N1030A-01

# Information Only Service Note

## N1030A 65 GHz Single Channel Optical Module

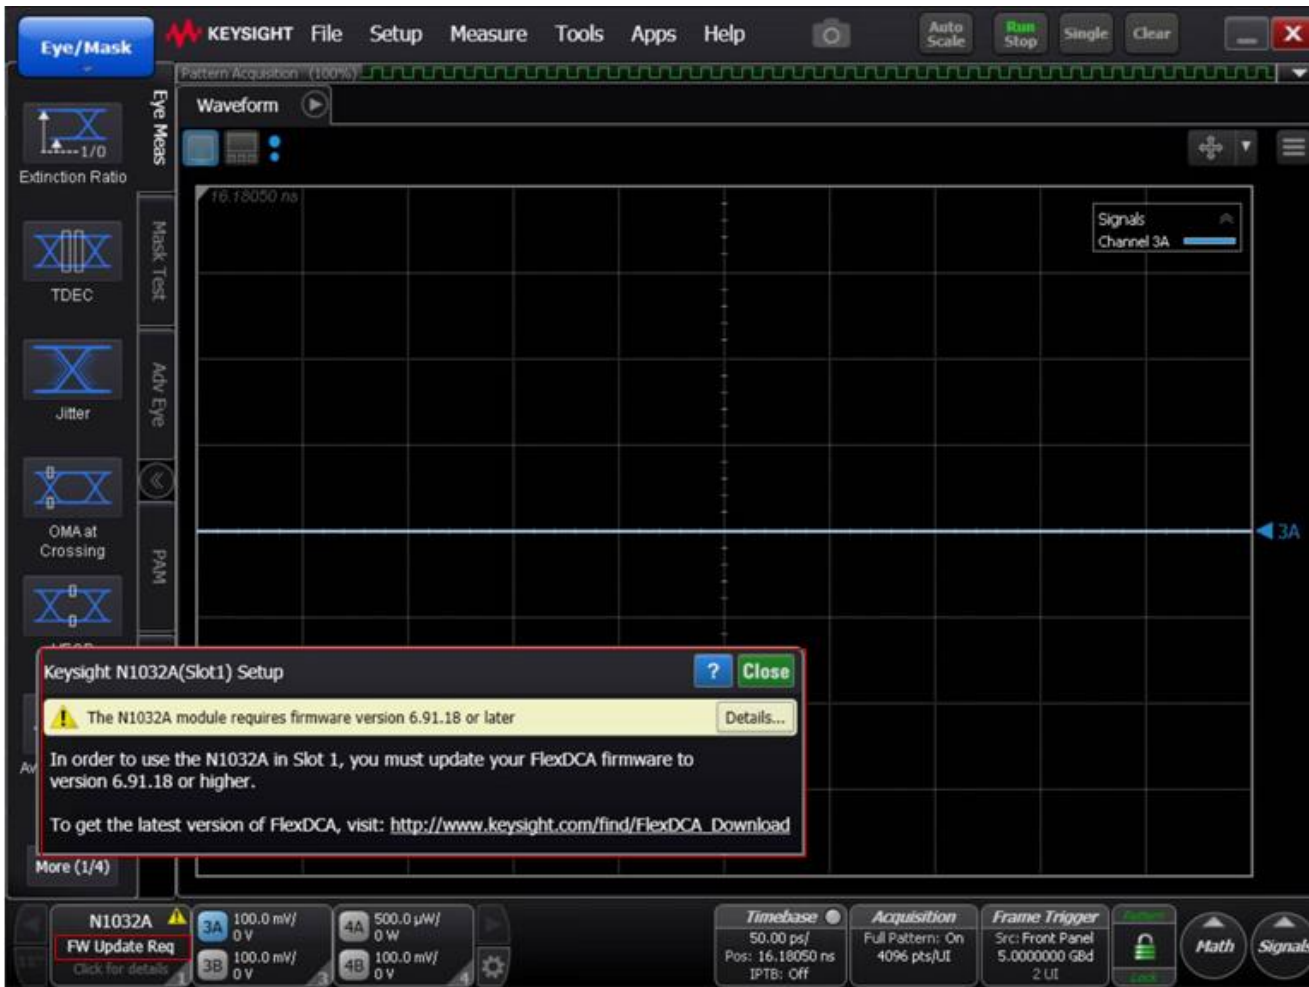
With the module installed in a DCA mainframe, if a message like the one below is displayed, FlexDCA must be updated to the indicated version (or later):

To update FlexDCA software, download from [www.keysight.com/find/flexdca\\_download](http://www.keysight.com/find/flexdca_download) and install. While only the indicated version is required, updating to the latest version is recommended.
